# HABITAT ARCHITECTURAL REVIEW BOARD

## TABBY ROADS

April 29, 2025

This letter shall serve as approval with conditions for the garage proposed at 32 Tabby Shell. Please note that some of the conditions in this letter might need to be incorporated prior to final HPC submission. Plans within the following files titled are the basis for this approval:

Fig 1. – Underpinning Example on Carriage House Steps

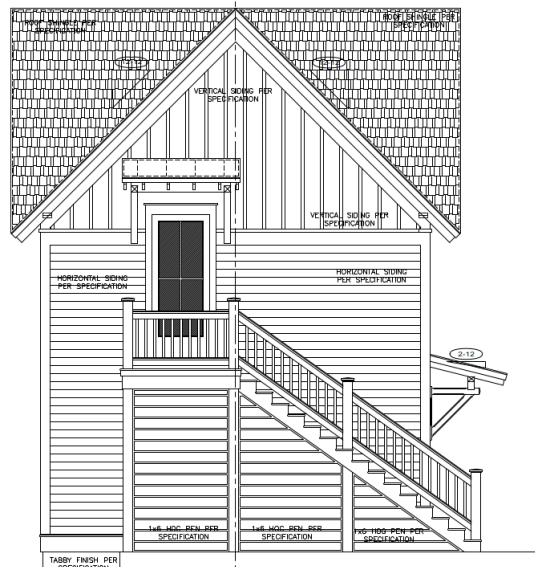
- Underneath the stairs on the right side elevation, the horizontal boards are not properly installed. Per UDO 5.15.60 for porches and decks, underpinning (in this case the hog fencing) must be recessed a minimum of 1" behind the pier (in this case the posts) such that the posts are exposed. See Fig 1.
- Under the stairs, fencing gap shall be no greater than 0.5". Per architectural guidelines service yards are intended to be 100% opaque and since applicant plans on storing trash bins here, this requirement must be met.

Fig 2. – Main House and Garage Eave Details

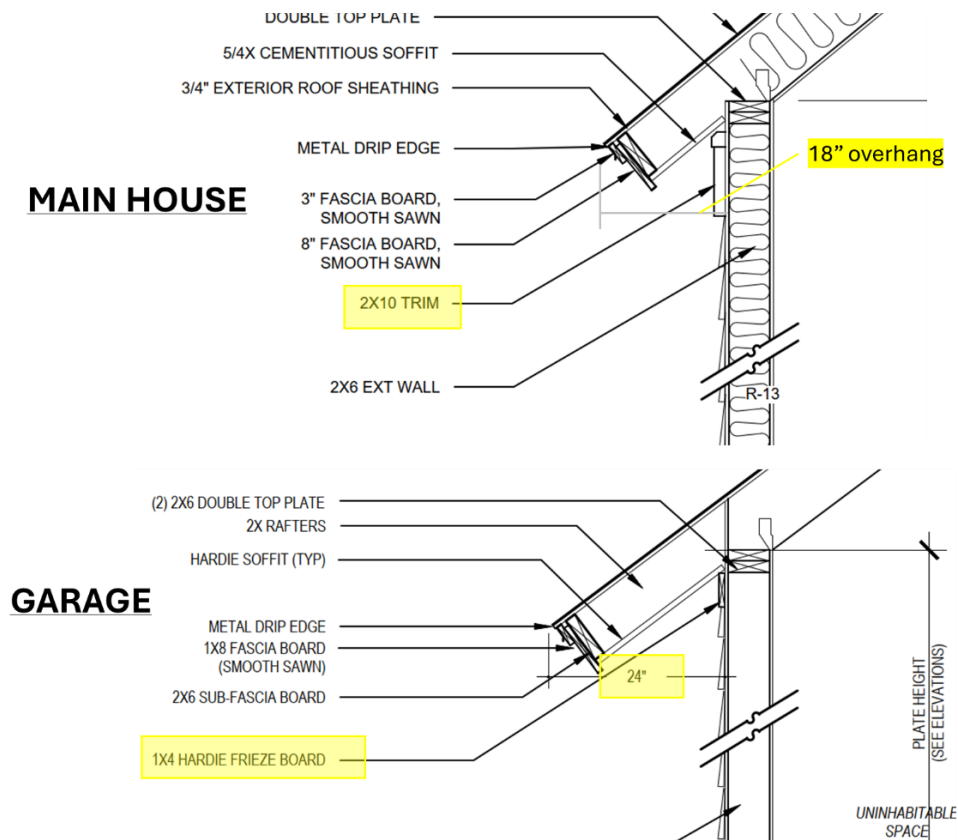
- Overhang and Frieze Board details need to match the main house. As submitted, these details differ as compared to the approved main house plans HARB has on file. See highlighted details in Fig. 2.

Fig 3. – Location of a Landing (possible code infraction)

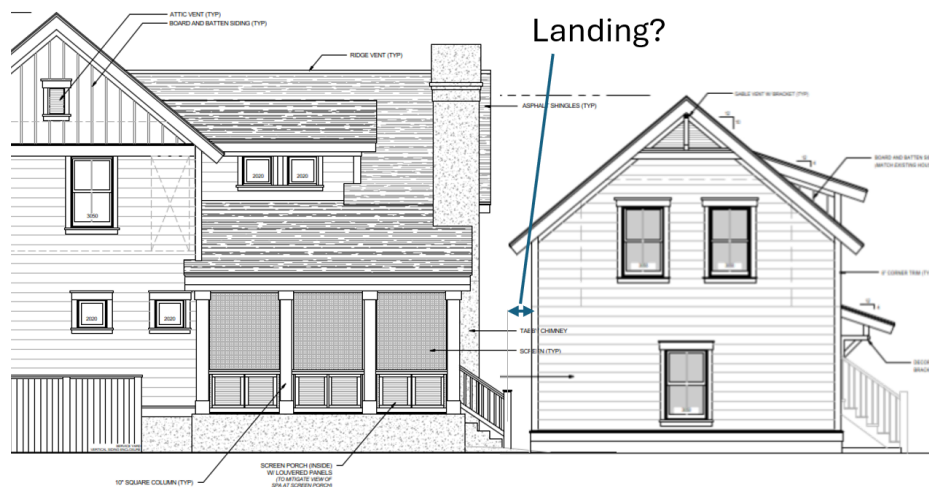
- It is the committee's belief that the position of the home is such that there might be a code violation at the bottom of the existing porch stairs (36" landing requirement). It is the responsibility of the applicant to verify that sufficient room exists between existing stairs and the new structure. See Fig. 3.

Fig 5. – Recommendation for compatibility massing with the main house

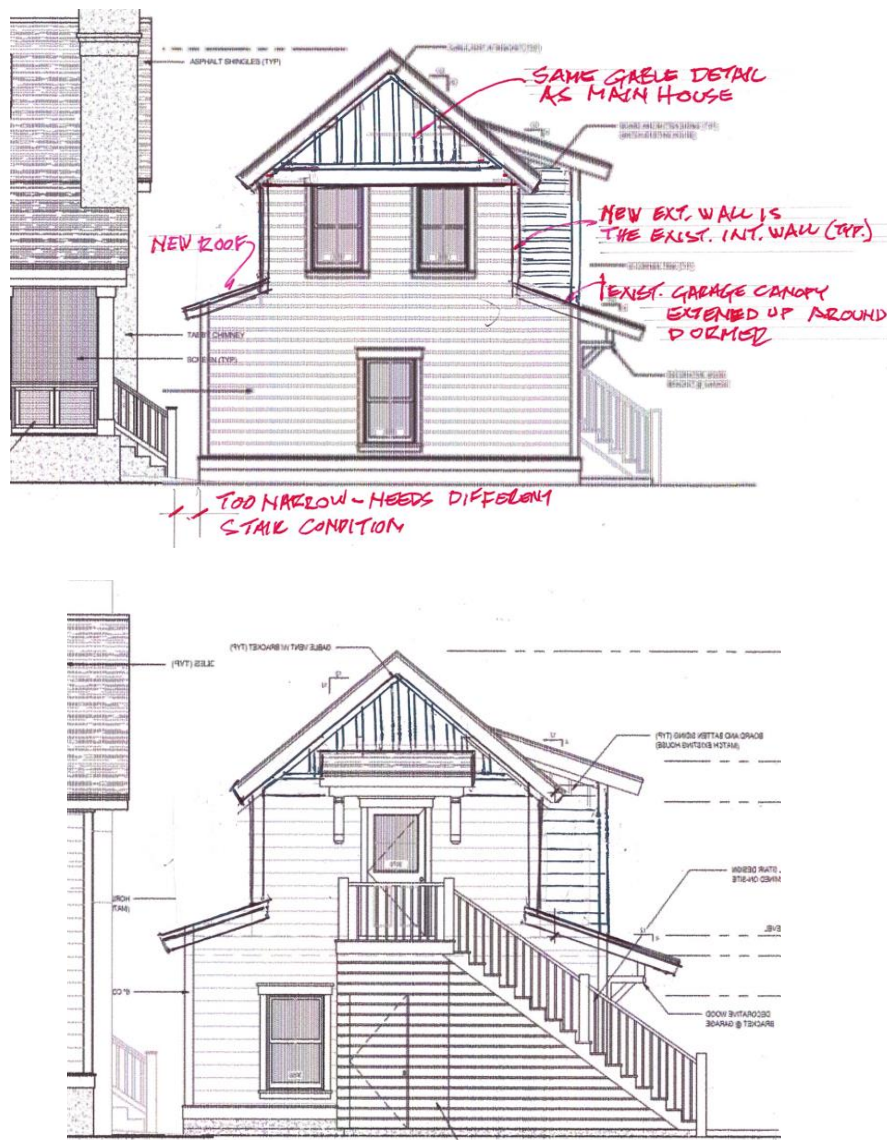
- It is **STRONGLY** suggested that the applicant break up the mass of the garage (as was done on the main house) to create more actual & visual separation between the two structures. Note that the new loft floor exterior walls are the actual interior walls, so incorporating this suggestion will not result in any loss of sq. footage. See Fig. 5.
